PLACE REVIERE SUBDIVISION

CATION NUMBER 21 DATE June 5, 2003

EQUEST Subdivision

PLACE RIVIERE SUBDIVISION

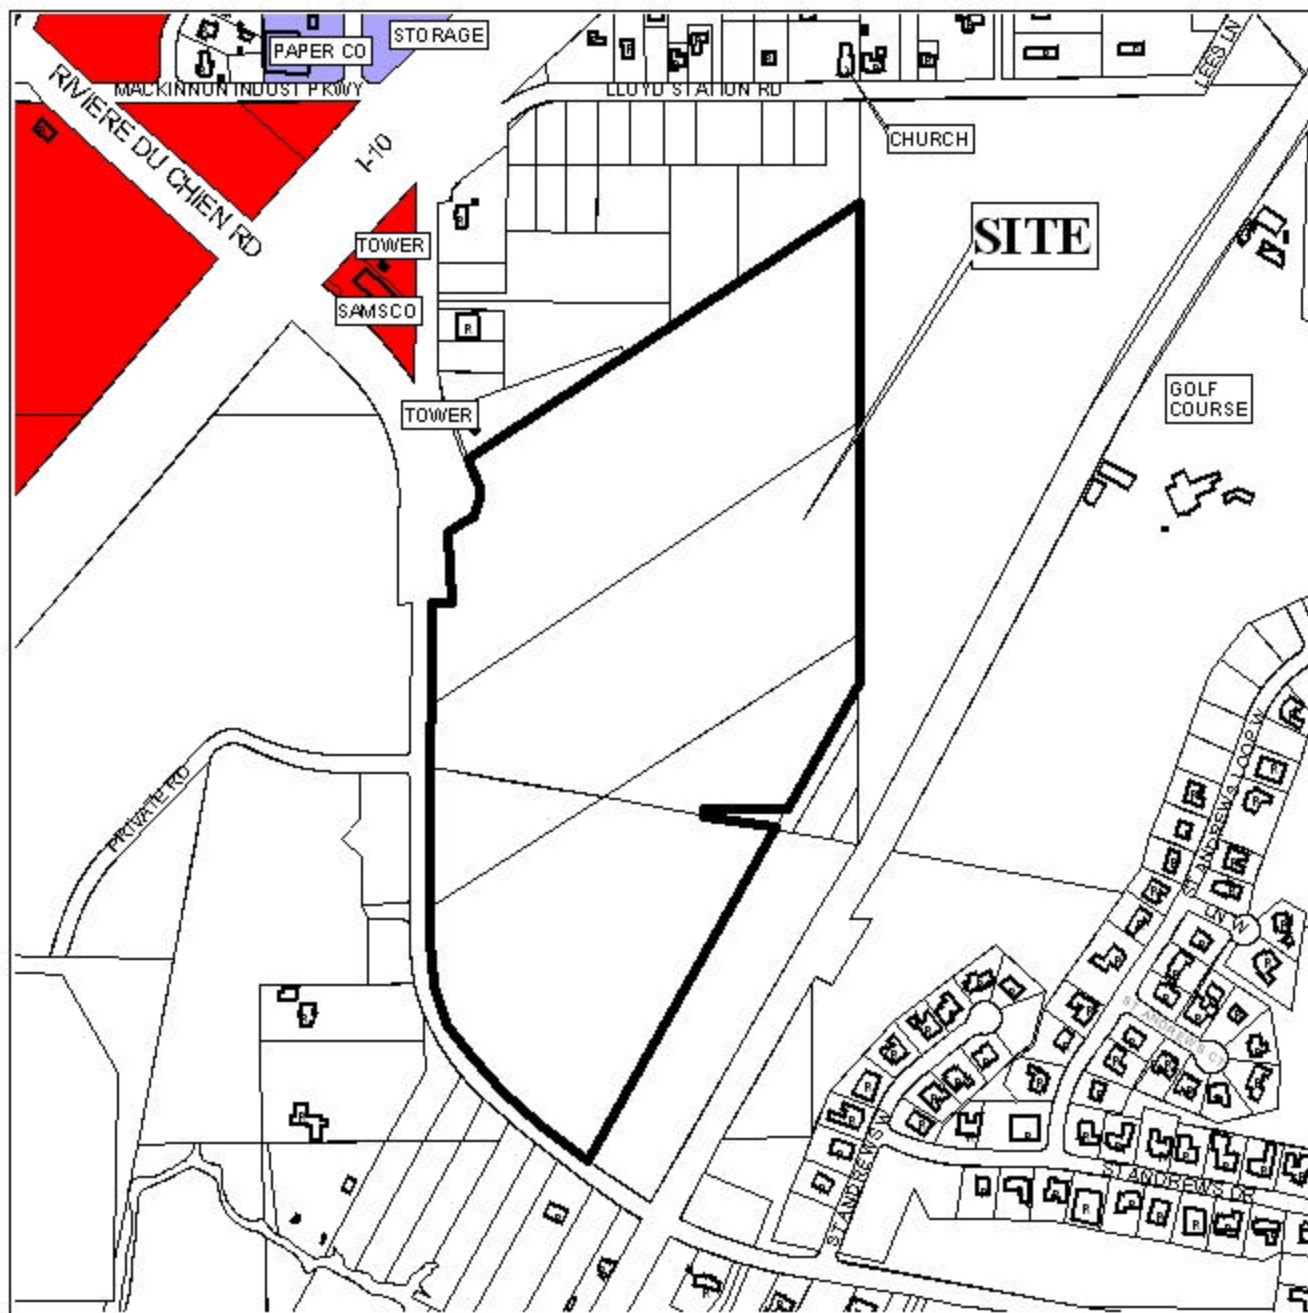
A note should be placed on the final plat stating that lots 1, 12, 13 and 33-42 be denied direct access to Riviere du Chien Road.

The plat meets the minimum requirements of the Subdivision Regulations and is recommended for Tentative Approval subject to the following conditions: 1) the placement of a note on the final plat stating that lots 1, 12, 13 and 33-42 be denied direct access to Riviere du Chien Road.
